K3 Technical Alert

Nov 17, 2009

Spurious TX sidebands due to C3 installation on early Rev C KPA3 PC boards.

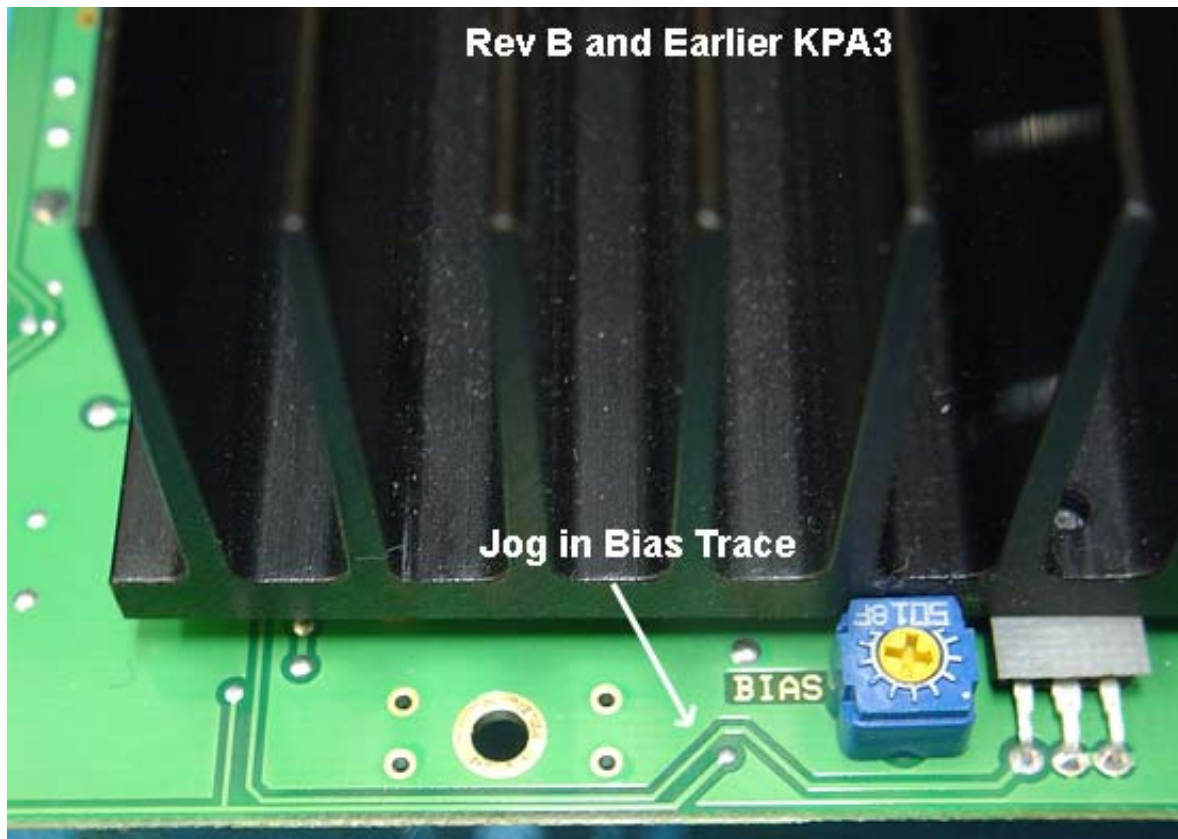
How to confirm if you are in this group: If your K3 is in the serial number and ship date range noted above, you may have a Rev C KPA3 PC board with capacitor C3 installed. To determine if you have a Rev C KPA3, you can examine the top side of the KPA3 (same side as its heat sink). Remove the K3 top cover and look at the KPA3 as installed. A portion of the KPA3 PC board is visible at the front edge of the heatsink as viewed from the front side of the K3 (see below). This is also visible through the top K3 cooling vents.

This is a Rev C KPA3. If your s/n or purchase date range is as noted above, check for installation of C3.

This is an earlier Rev KPA3 and does not need to be checked for C3.

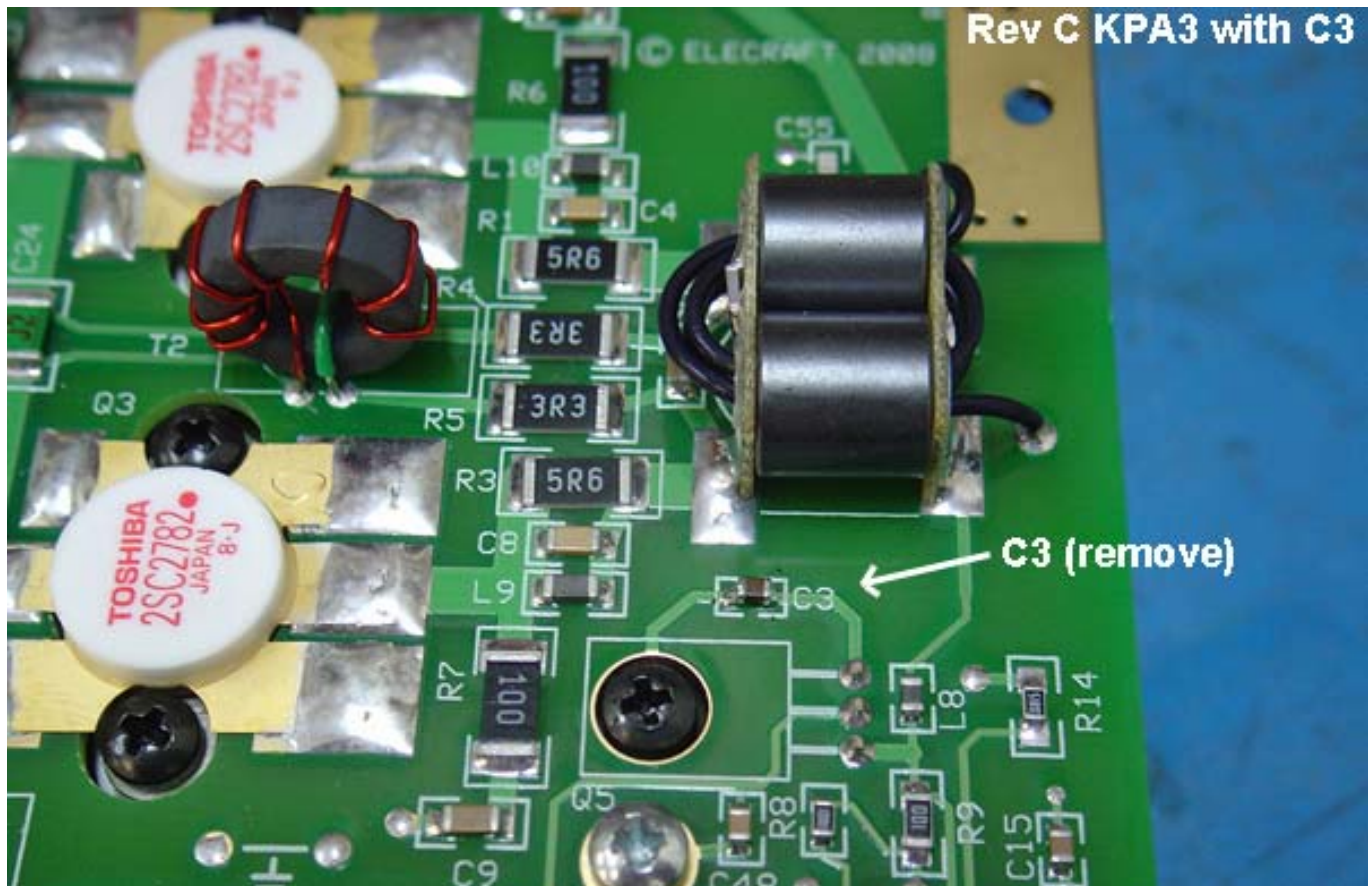
To determine if you have C3 installed on a Rev C KPA3, inspect the reverse side of the KPA3 PCB (see pictures on next page).

If C3 is present as shown on the above picture, remove it using a soldering iron. A 1/8" tip iron should be able to easily heat both ends of the capacitor, easily removing it from the board.

Corrective Action: Remove capacitor C3 from the Rev C KPA3 PCB as described below.
